Re: **Workplan: Monitoring Well Destruction, Waste Disposal and Closure Reporting**
Sallee's Paint & Auto Body
1049 9th Avenue
Oakland, CA
RO #0000308

**Addendum to the Workplan: Monitoring Well Destruction,
Waste Disposal and Closure Reporting
Salle's Paint & Body Shop
1049 9th Avenue
Oakland, California**

SITE PLAN
 1049 9th Avenue
 Oakland, California

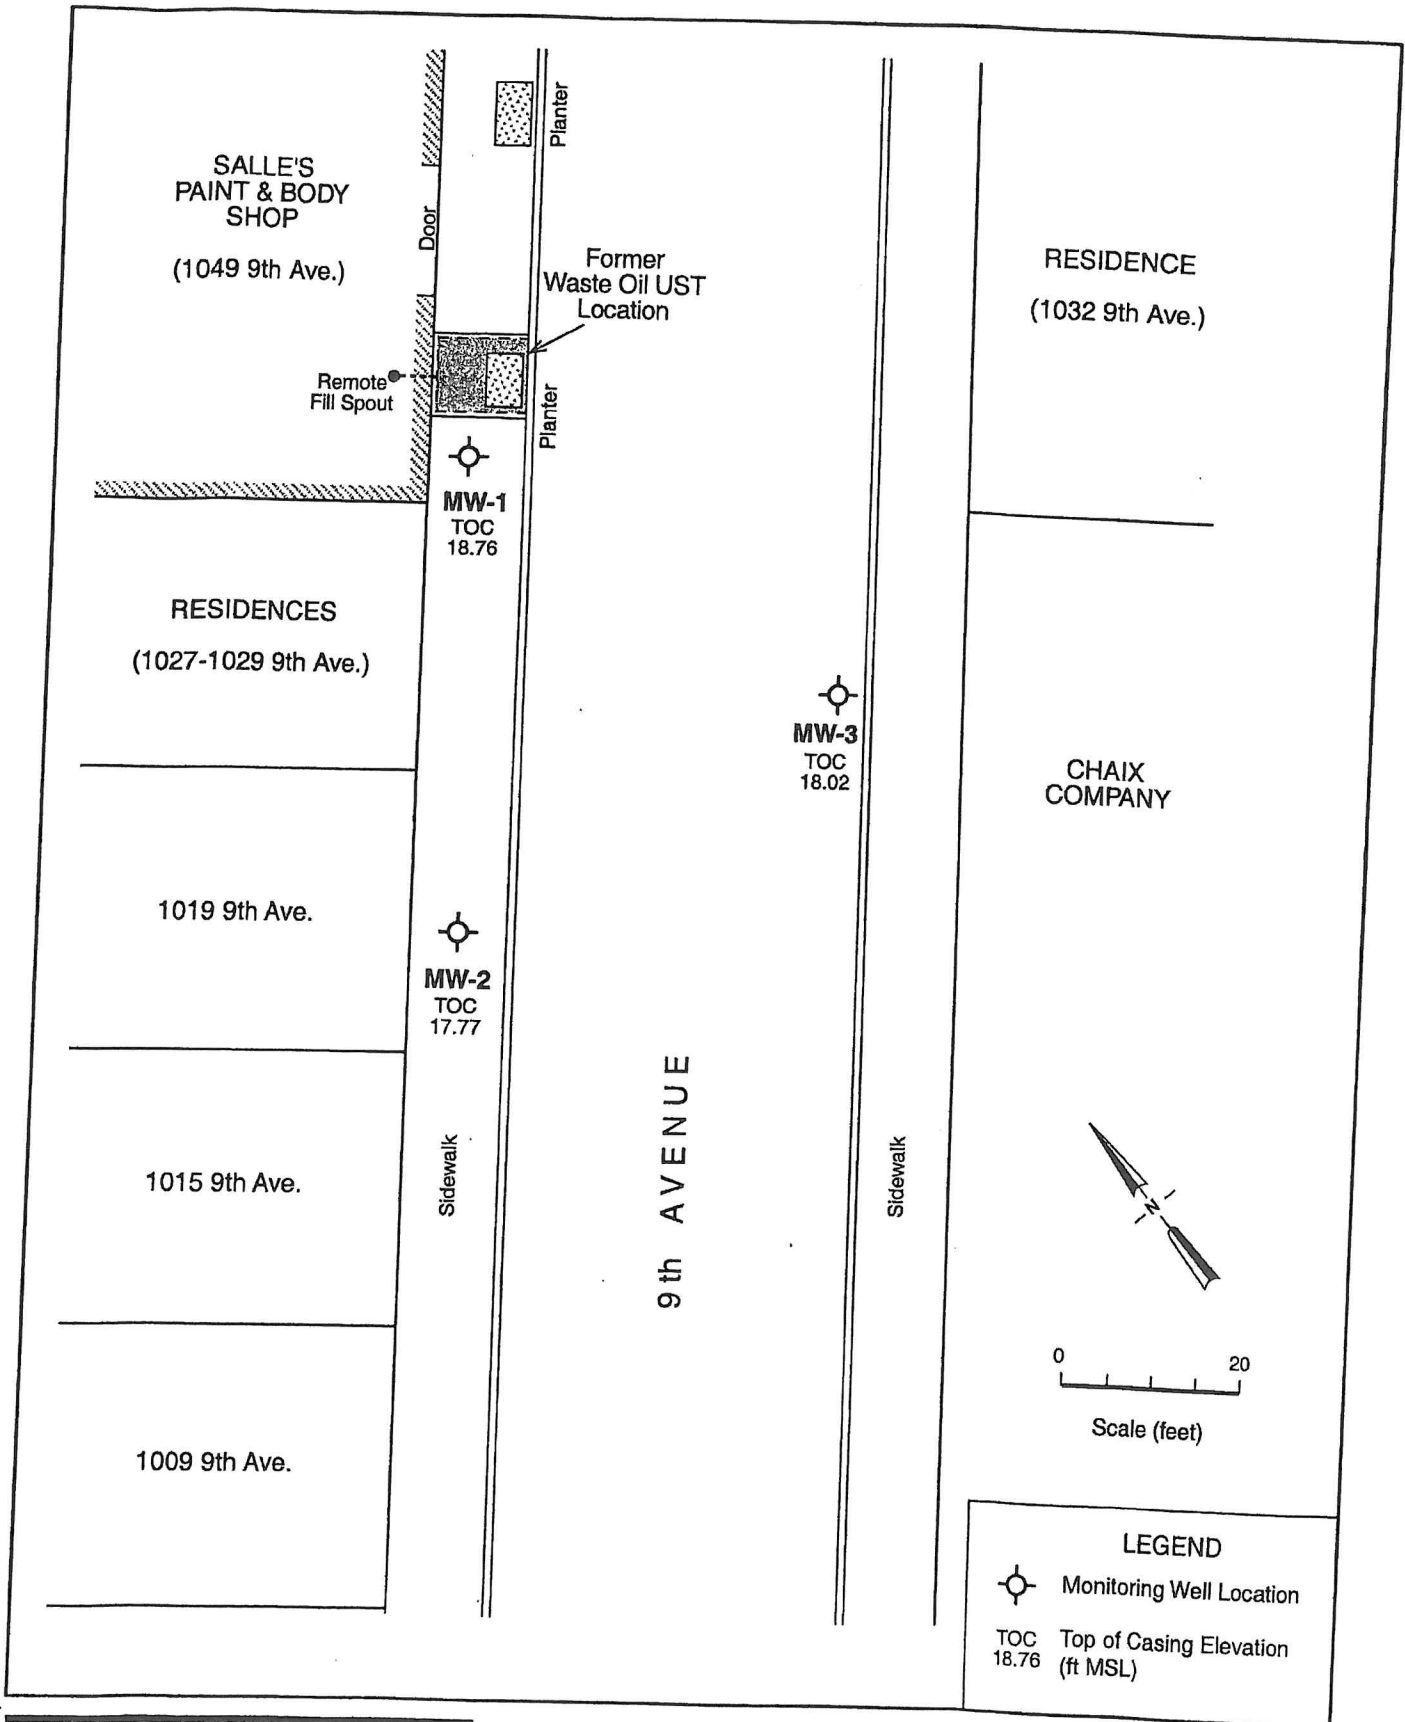
Edd Clark & Associates, Inc. (EC&A) is pleased to present this addendum to the March 31, 2015 *Workplan: Monitoring Well Destruction, Waste Disposal and Closure Reporting* for 1049 9th Avenue (site) in Oakland, California (Figures 1 and 2). In response to EC&A's Workplan, referenced above, the Alameda County Health Care Services (ACHCS) stated in an email dated May 7, 2015, that project monitoring wells (MW-1, MW-2 and MW-3) could be decommissioned by pressure grouting. EC&A subsequently proposes that MW-1, MW-2 and MW-3 be decommissioned using pressure grouting methods. Clear Heart Drilling, Inc. of Santa Rosa, California will pressure-grout each of the wells by filling them with cement grout and attaching an air compressor with a pressure gauge to the top of the PVC well casing. A pressure of 25 pounds per square inch (PSI) will be maintained for a minimum of five minutes. If the pressure and/or grout level drops, more grout will be added and the process repeated until 25 PSI is maintained and the grout level remains stable. All other details outlined in the March 31, 2015 Workplan will be followed.
